## Department of Planning and Zoning

**TO:** Development Review Board  
**FROM:** Scott Gustin *SG*  
**DATE:** August 2, 2011  
**RE:** 11-0394PD; 88 South Willard Street

**Request:** Combined preliminary/final plat review of planned unit development (PUD) to construct new detached residential structure for one new unit with associated parking

DRAWN BY  
WLS  
DESCRIPTION  
Proposed  
Primary

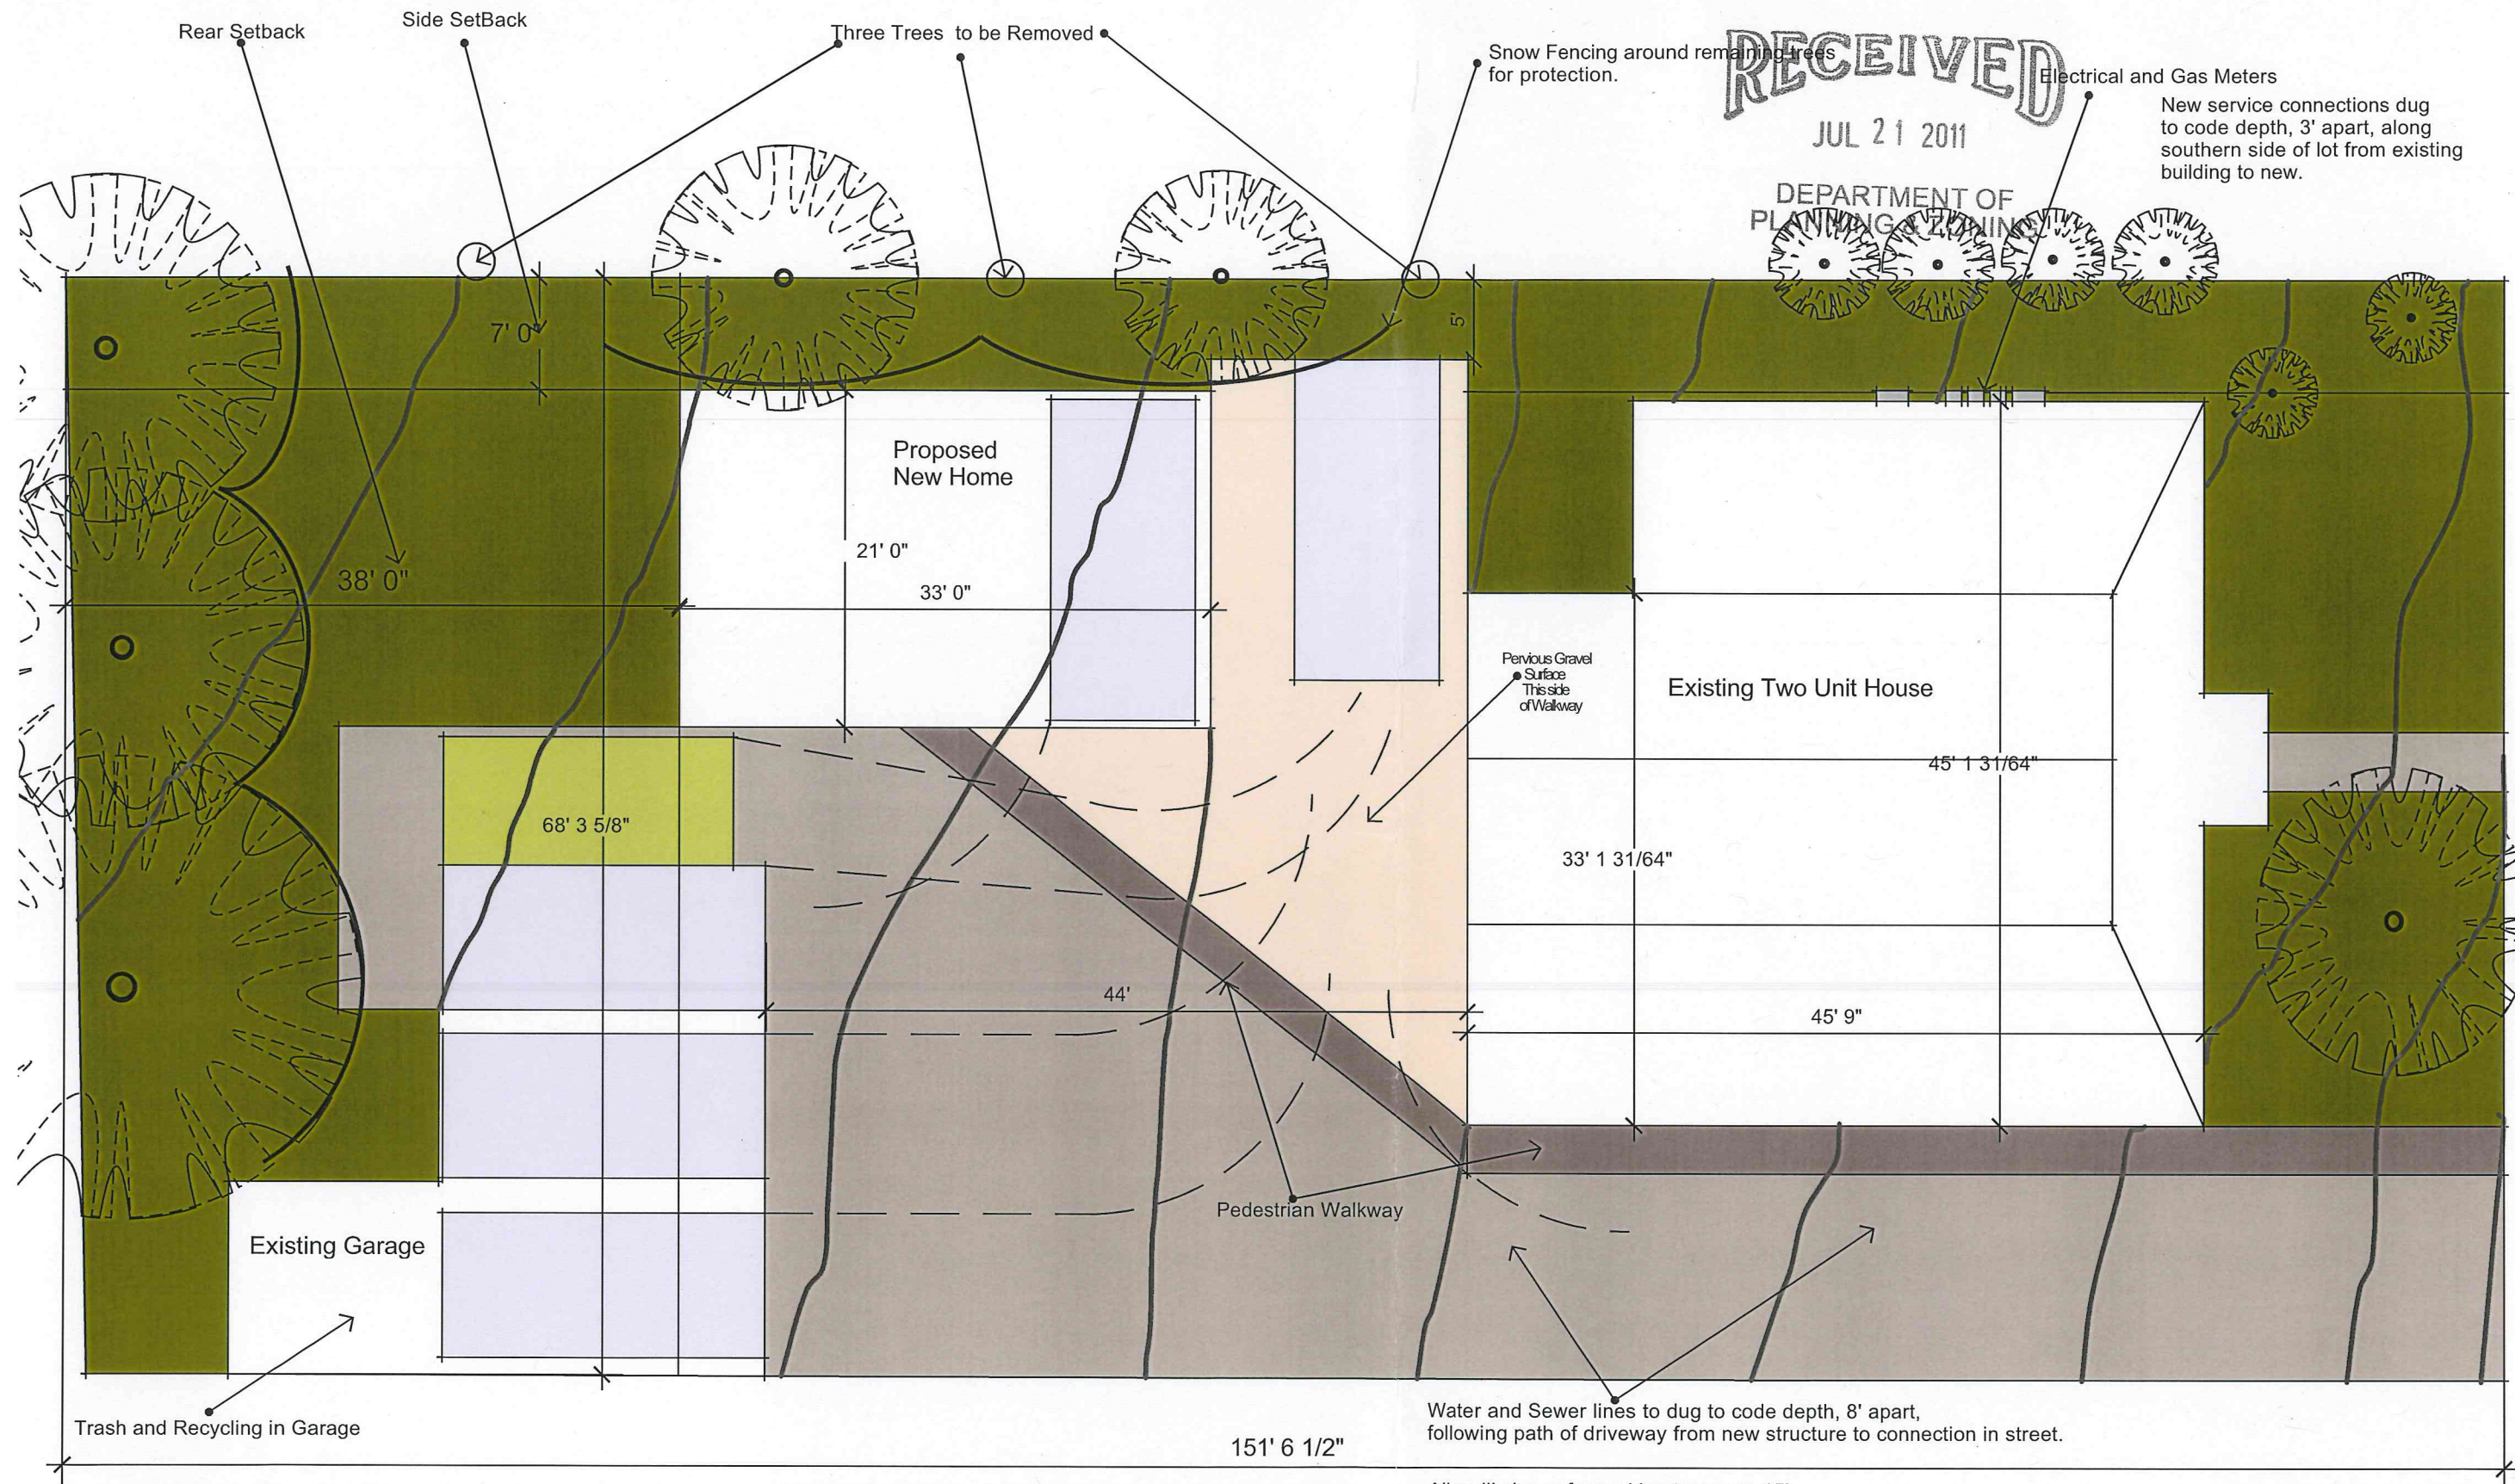
The minimum required rear yard setback is 25% of the lot depth (and in no event less than 20'). The proposed rear yard setback has been revised to 37'; however, 38' is the minimum required on this 151.6' deep lot. The building location must be shifted forward by 1'.

Parking is appropriately located behind the existing residence. The parking arrangement has been revised to delete 2 parking spaces and to improve circulation. As now proposed, each vehicle has sufficient room to turn around and drive forwards onto the street. Note that the garage space in the new building has switched to the opposite side of the building. The site plan reflects this change; however, the elevation drawing needs to be updated accordingly. **(Affirmative finding as conditioned)**

The site plan depicts existing trees, including those to be removed. No new landscaping is depicted and should be. **(Affirmative finding as conditioned)**

Side yard setbacks are compliant. The rear yard setback needs to be revised slightly as noted previously. **(Affirmative finding as conditioned)**

- a) The new dwelling unit moved forward to comply with the rear yard setback;
  - b) Updated building elevations to reflect modified garage location; and,

- c) New landscaping (including location, species, and size at time of planting).
3. **Prior to release of the zoning permit**, written approval of erosion control and stormwater management procedures shall be obtained from the Stormwater Administrator.
